SUBJECT: Transmittal of Westinghouse Responses to US NRC Requests for Additional Information on the AP1000 Application for Design Certification

AP1000 DESIGN CERTIFICATION REVIEW

RAI Number: 230.018 (Response Revision 3)

Table 3.7.2-2 (Sheet 2 of 2)

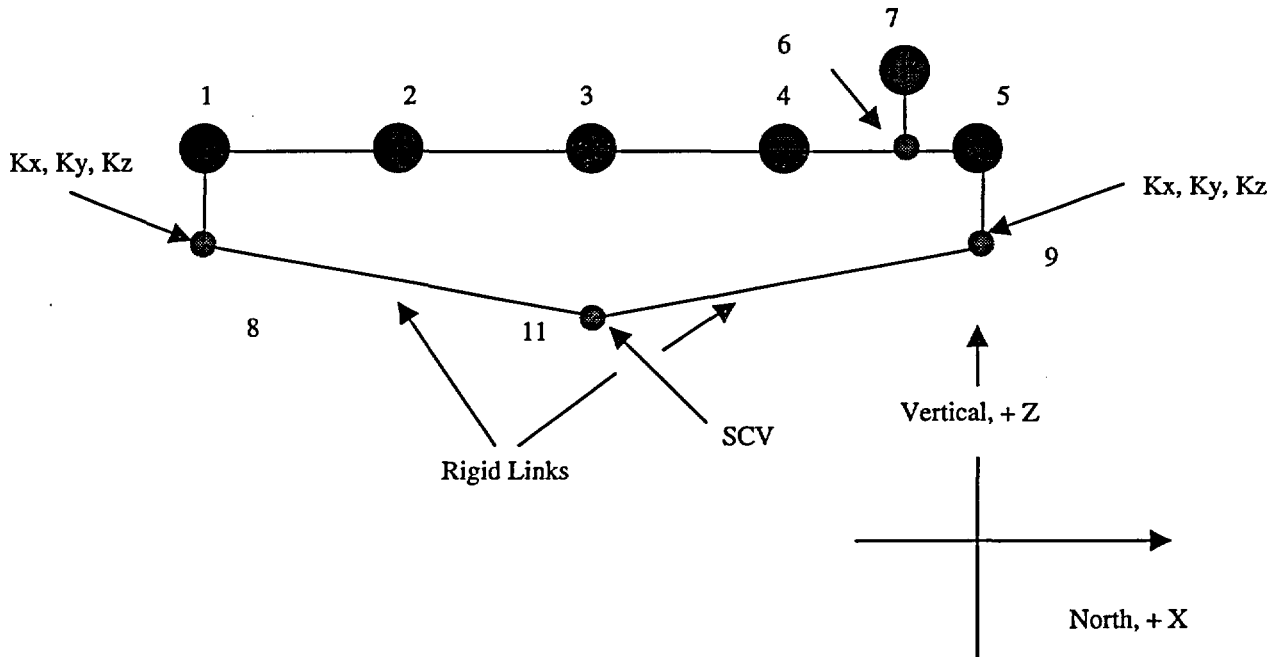
The proposed DCD revisions sufficiently described the multi-mass polar crane model, but did not provide a sufficient basis for the significantly reduced vertical acceleration of 1.13g for the steel containment vessel. Westinghouse agreed to provide additional justification regarding the reduction of the vertical acceleration by using the new polar crane model.

Add sheet 2 to Table 3.7.2-2 showing modal properties of steel containment vessel combined with polar crane

In revision 1 to this response Westinghouse included Table 3.7.2-2 (sheet 2) in the DCD showing modal properties of the steel containment vessel combined with the polar crane.

Figure 230.018-4 Comparison of Nuclear Island Models - Vertical FRS at Polar Crane Elevation

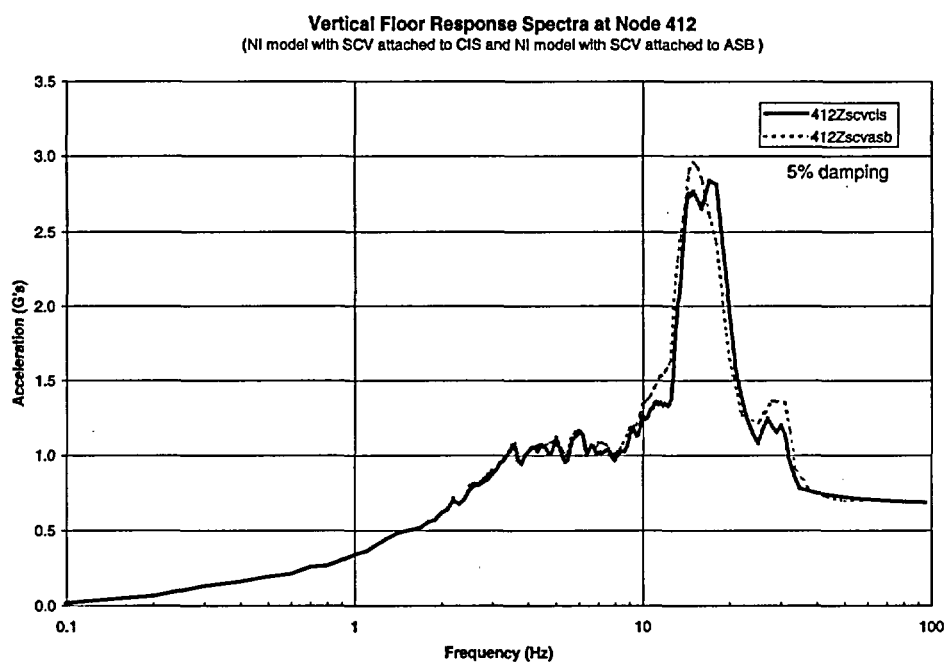
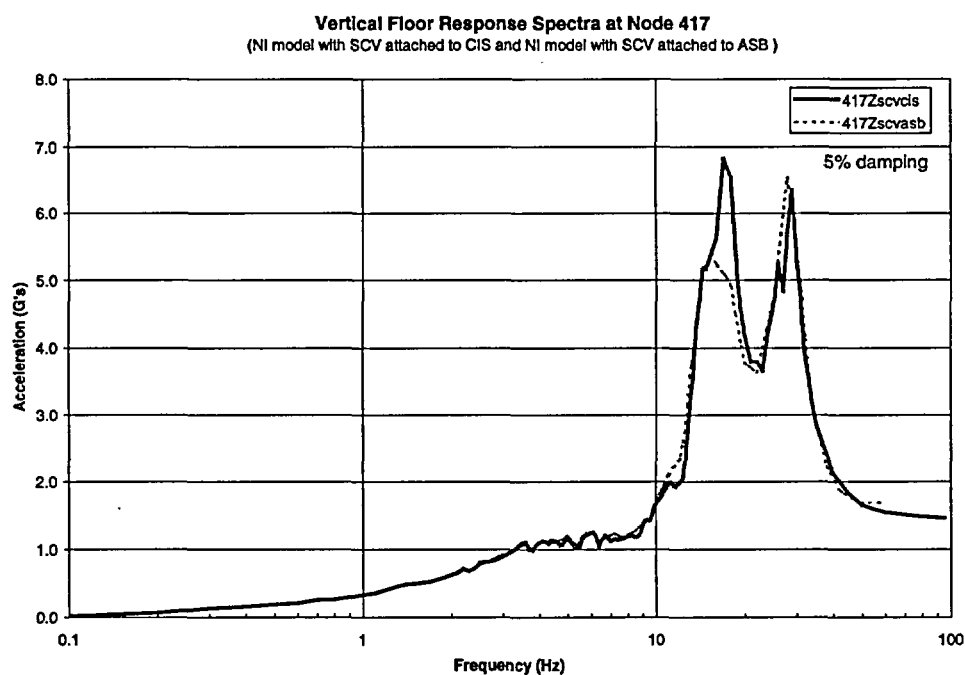
The interaction between the steel containment vessel and the rest of the nuclear island was investigated. As shown in Table 230.18-1 the steel vessel and polar crane have significant frequencies at 16.37 Hz and 27.34 Hz. The nuclear island stick model has significant vertical frequencies at about 16 Hz (see DCD Table 3.7.2-4) and between 25 and 30 Hz. The vertical modes of the auxiliary and shield building in the nuclear island stick analyses were found to be reducing the response of the containment vessel at the polar crane elevation and amplifying the response of the top of the containment vessel. The containment vessel stick model is attached by a rigid link to the auxiliary and shield building stick at elevation 99' as shown in DCD Figure 3.7.2-18. At this elevation the centroid of the auxiliary and shield building cross section is far from the center of the containment vessel and rotation of the auxiliary and shield building stick affects the containment vessel vertical response. The structural configuration is shown in DCD Figure 3.7.2-12, sheet 9. Due to flexibility of the slab in the annulus at elevation 100', it was also recognized that the vertical displacement of the containment vessel would be controlled primarily by the containment internal structures and the cradle rather than by the shield building.

The nuclear island stick model was revised to connect the containment vessel stick to the CIS stick at elevation 99' rather than to the ASB stick. Floor response spectra on the containment vessel are compared in Figures 230.018-4 and 230.018-5 for this revised model against those for the model included in DCD Revision 3. The peak at 16 Hz increases by about 30% while the response at other frequencies is unchanged.

Figure 230.018-6 Comparison of FRS Methods - Vertical FRS at Polar Crane Elevation

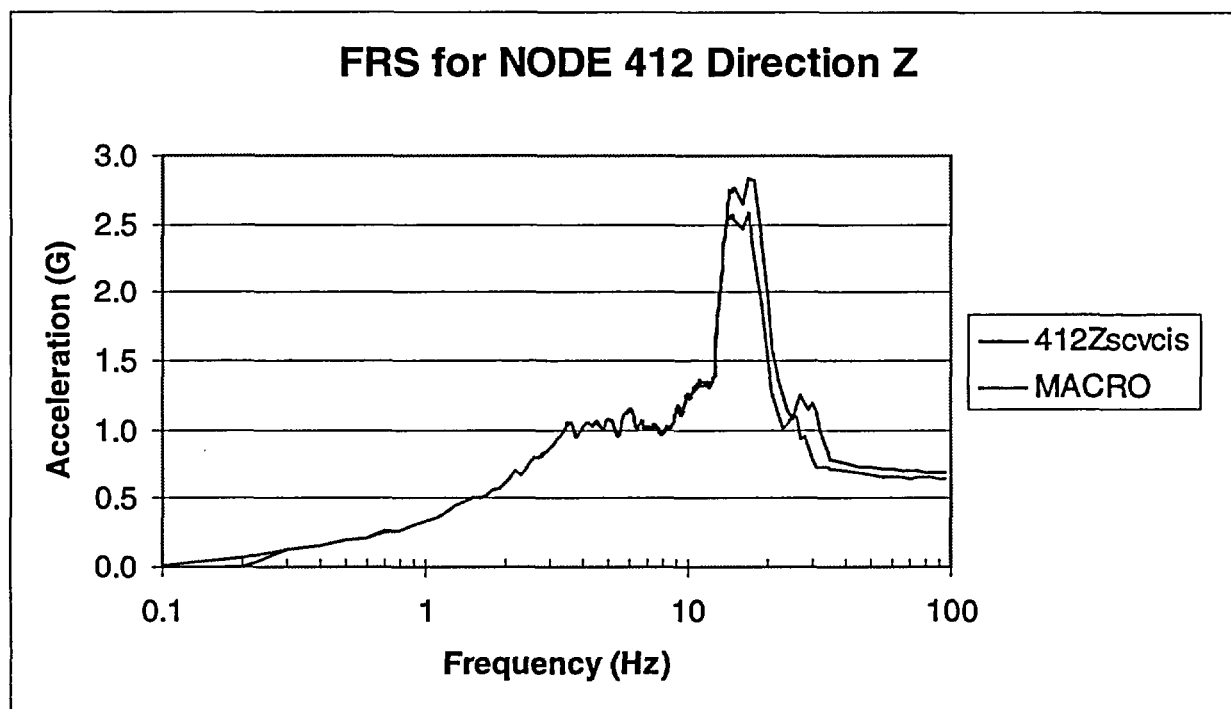
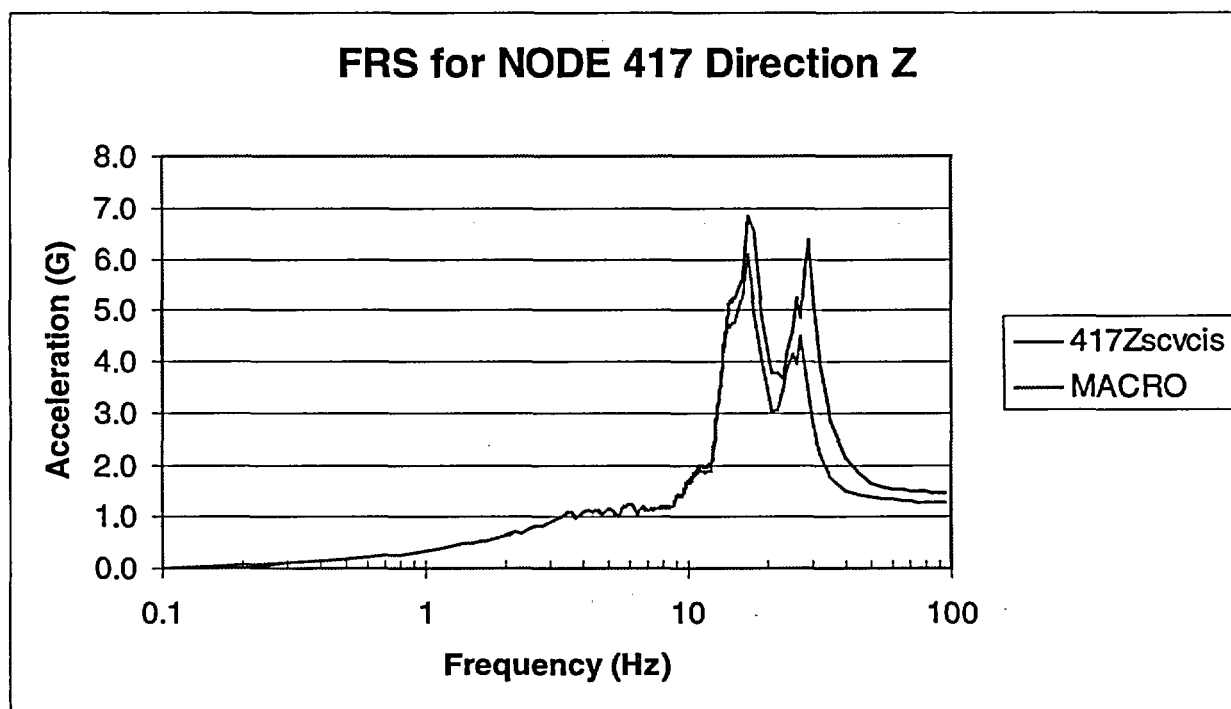
Floor response spectra shown in the DCD have been generated using the ANSYS post – processor that is conservative in the higher frequencies. Figures 230.018-6 and 7 show comparisons of the ANSYS post-processor against results obtained from another more accurate post-processor (macro) for the nuclear island model with the steel containment vessel attached to the containment internal structure. These figures explain why the spectra shown in the DCD calculated using ANSYS do not appear to converge to the zero period acceleration.

- Revise the connection at the base of the steel containment vessel stick in the nuclear island analyses. The base of the stick will be connected to the containment internal structure node at elevation 98' instead of to the auxiliary and shield building stick.
- Revise the truss elements at the lower elevations of the auxiliary and shield building model. This reduces their eccentricity and slightly improves the matching of the stick model modal properties to those of the finite element shell model. This change is conservative since it increases the vertical response of the auxiliary and shield building above that predicted in the dynamic analyses of the shell model.
- Develop floor response spectra using the more accurate post-processor instead of the standard ANSYS post-processor.
